South Carolina  
Department of Transportation

MEMORANDUM TO GROUP LEADERS AND CONSULTANTS

SUBJECT: Thrie Beam Connector Details

**SUBJECT: Standard Drawings for Guardrail**

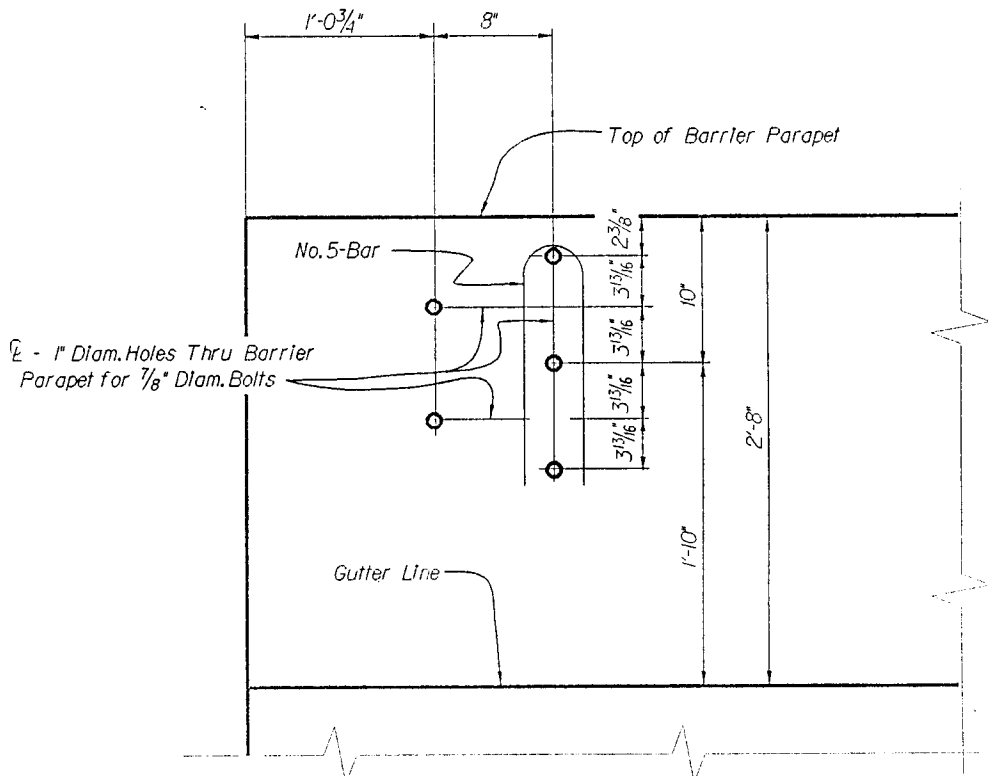
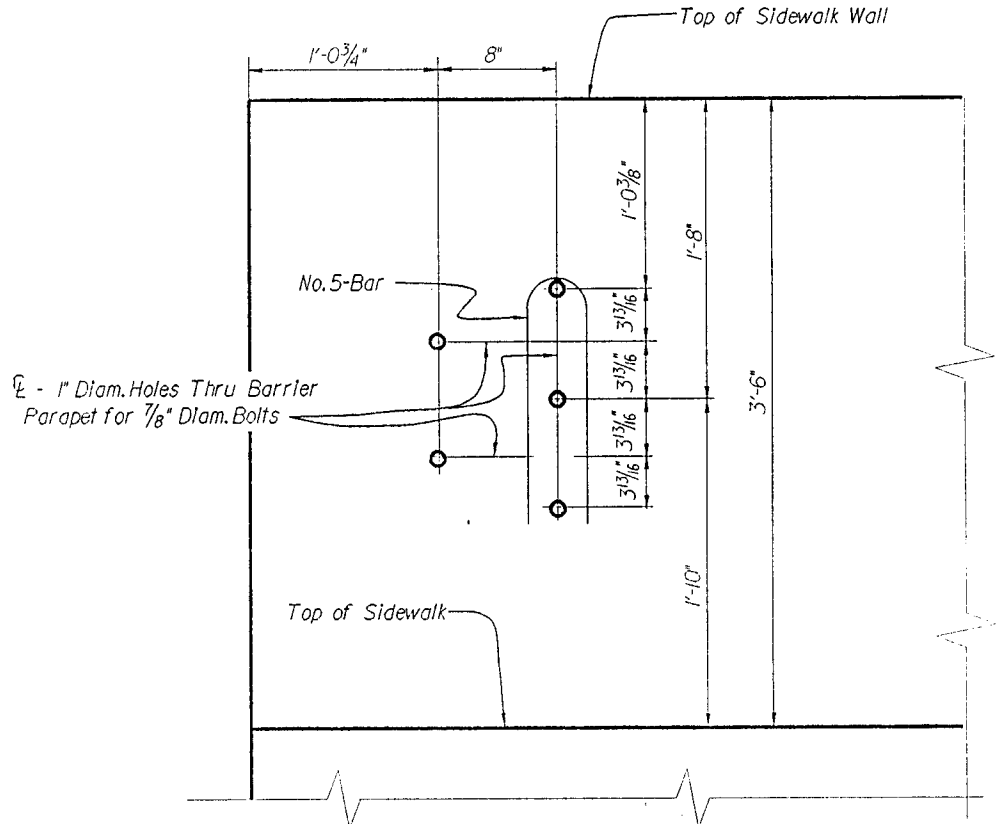
It has been brought to our attention that the present dimensioning shown on Road Standard Drawing No. 805-7, 805-9 and 805-9A for the Thrie Beam Terminal Connector pattern does not correspond with (AASHTO-AGC-ARTBA) TAST FORCE NO. 13 MANUAL.

The attached drawing shows the correct dimensions. Beginning with the September, 1996 Letting, all projects should be detailed using these dimensions.

The affected Road Standard Drawings will be revised and are scheduled for disbursement this fall.

**TERMINAL CONNECTOR**

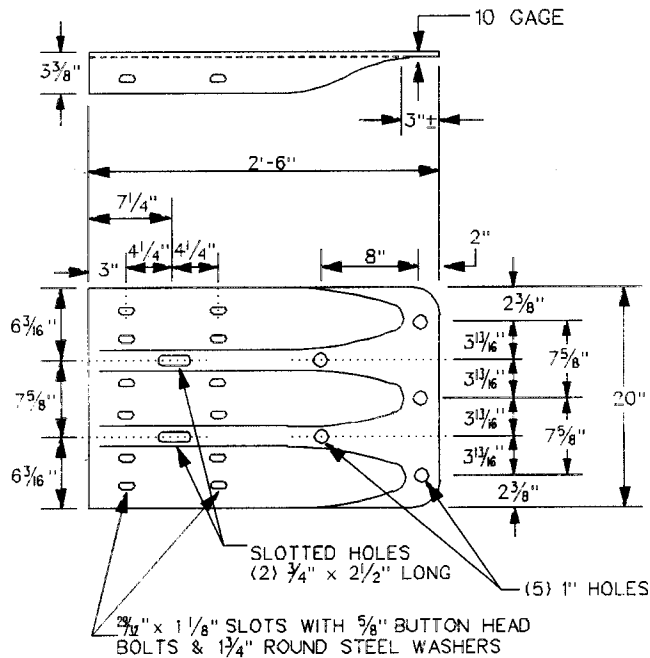
It has been brought to our attention that the present dimensioning shown on Standard Drawing No. 805-7, 805-9, & 805-9A for the Thrie Beam Terminal Connector pattern does not correspond with the (AASHTO-AGC-ARTBA) Task Force No. 13 Manual. Below is the revised drawing. The new dimensions will appear in our revisions scheduled for disbursement by this fall.
